Recall Bulletin

PRODUCT SAFETY RECALL

SUBJECT: Front Windshield Wiper Operation – Replace Module Cover

MODELS: 2003 HUMMER H2

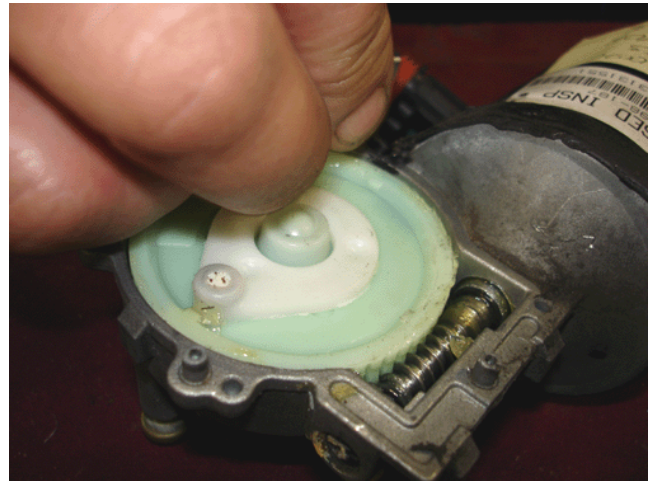
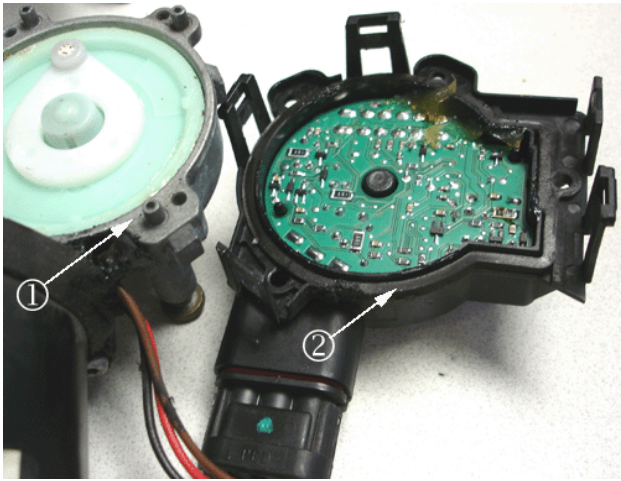
1. Remove the wiper arms. Lift the arm and raise it approximately 50 mm (2 in) from the glass. Release the locking tab at the base of the arm by sliding the tab outward with a flat bladed tool. With a flat bladed tool, lift the wiper arms off of the post.
2. Remove the air inlet grille panel caps by applying upward pressure to the caps.
3. Remove the air inlet grille panel. The panel has two screws, one on each end of the panel and two push pins in the front of the panel. Use a flat bladed tool to release the four retainers under the panel.
4. Move the panel forward to gain access to the wiper motor.
5. Disconnect the electrical connector from the module.

Wiper motor shown out of vehicle for illustration purposes only.

6. Release the five retainers (1) that retain the cover/module to the motor.

Wiper motor/module shown out of vehicle for illustration purposes only

7. Inspect the plastic module cover (2) and metal module (1) sealing surfaces for butyl.
 - If butyl is on either sealing surface, discard the plastic cover and replace it with a new cover. Ensure that all of the butyl is removed from the metal sealing surface **BEFORE** installing a new cover. Use a flat-blade screw driver or razor blade to remove the butyl from the metal surface.
 - If no butyl is on either sealing surface, re-install the cover. Refer to Step 8.
8. Install the wiper cover/module. Align the retainer with the tang on the motor and push down.
9. Install the electrical connectors to the cover/module.
10. Make sure wipers are operational.
11. Install the air inlet grille panel. Align the air inlet grille to the vehicle and secure by pushing downward on the four retainers. Install the push in retainer and tighten the two end screws.
